### PLANNING AND ZONING COMMISSION MEETING Tuesday, April 26, 2022 • 7:00 p.m. West Branch City Council Chambers, 110 N. Poplar St.

AGENDA ITEM:	Review and approve Croell Redi Mix temporary concrete plant Site Plan.
PREPARED BY:	City Clerk, Leslie Brick
DATE:	April 13, 2022

Croell Redi Mix has been awarded two large projects near West Branch and therefore needs to set up a temporary concrete plant to service the projects. The site chosen is the southeast corner of Fawcett Drive and South Baker Avenue. Croell has submitted a site plan drawing of the location site and City Engineer Dave Schechinger asked the following questions. (Croell's responses in RED)

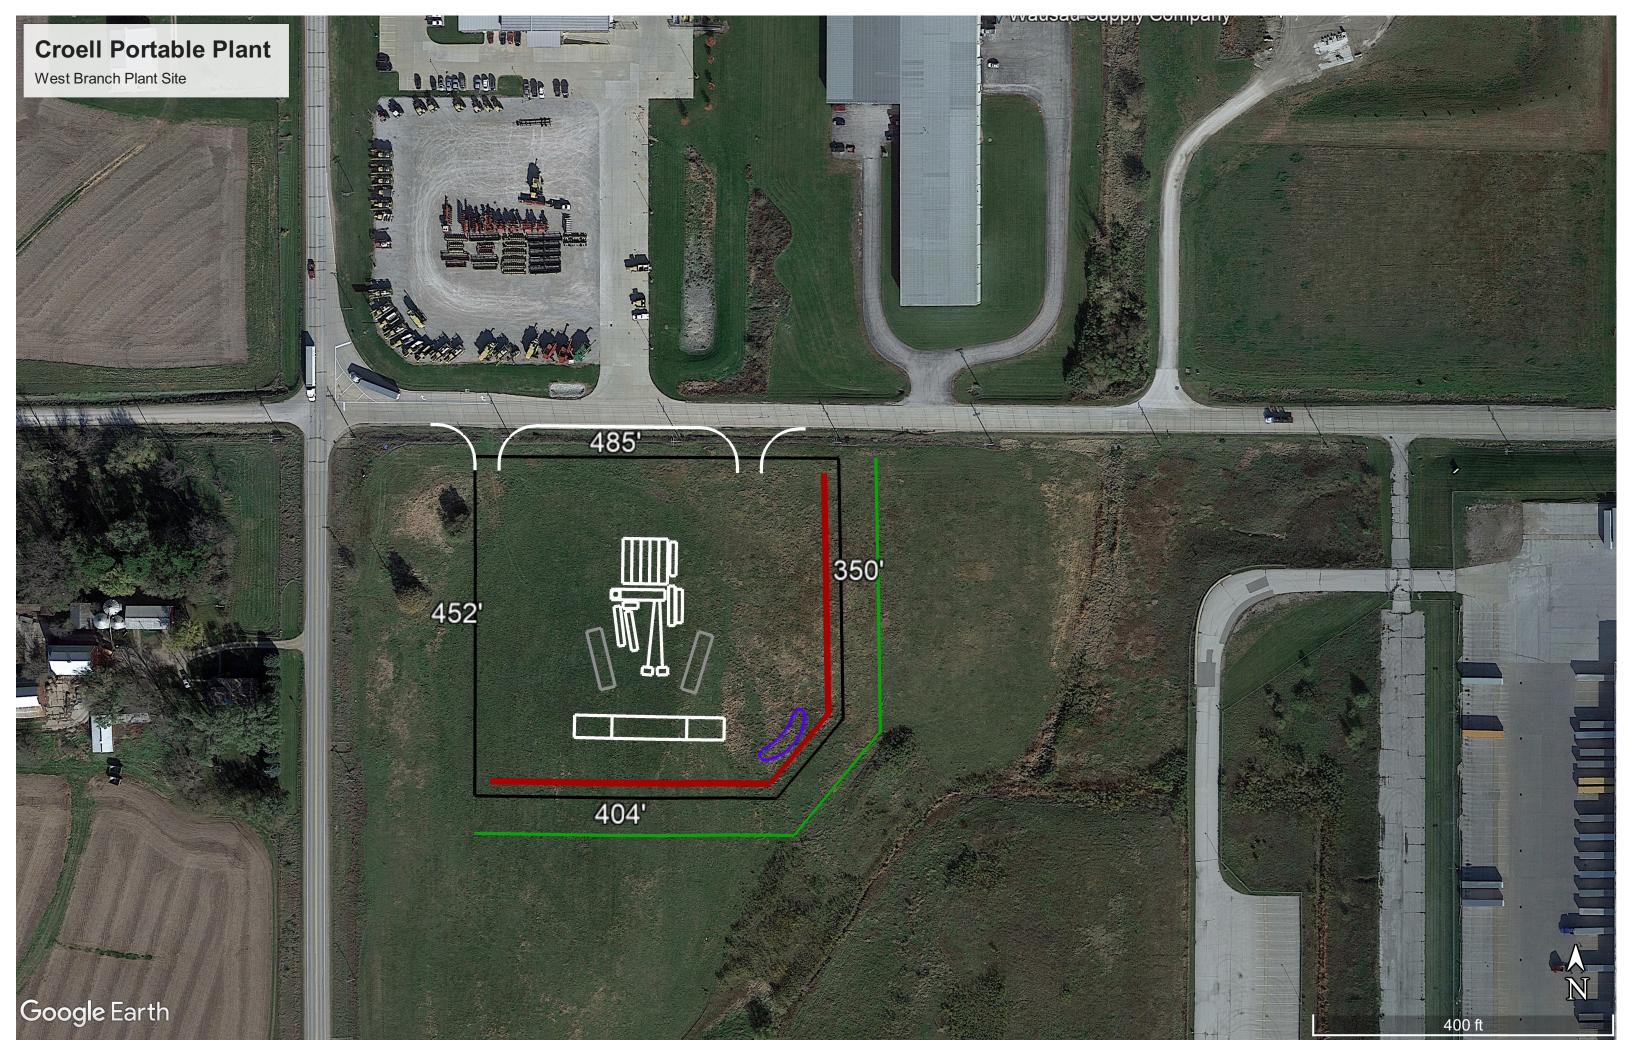
How long will this be in place? 2 year project, 30 working days June – August 2022 & 30 working days June – August 2023.

How many trucks they plan to run in and out of this site each day. 100 loads coming in, 130 loads going out

What is the peak trips per hour they would expect to see during peak production. 240 loads out, 160 loads in

What will the surfacing be for the driveway and parking? Will dust control be required? Hard surface traffic flow & parking, dust control will be used in compliance with the IA DNR Air Permit (as needed)

Will they require water service to the site? If so, what size meter? Hydrant service that is onsite, 2" meter and backflow

Will containment be provided for any onsite fuel storage? What about additives? Double walled fuel tanker, admixtures are stored in steel tanker (built in "Premier" spill containment)

Will a truck wash be provided? How is the washout captured or contained? No truck wash will not be provided, tracking pad will be used. Water truck and truck broom will be on site for use when needed. Site Storm water/pond area will be graded for the site.
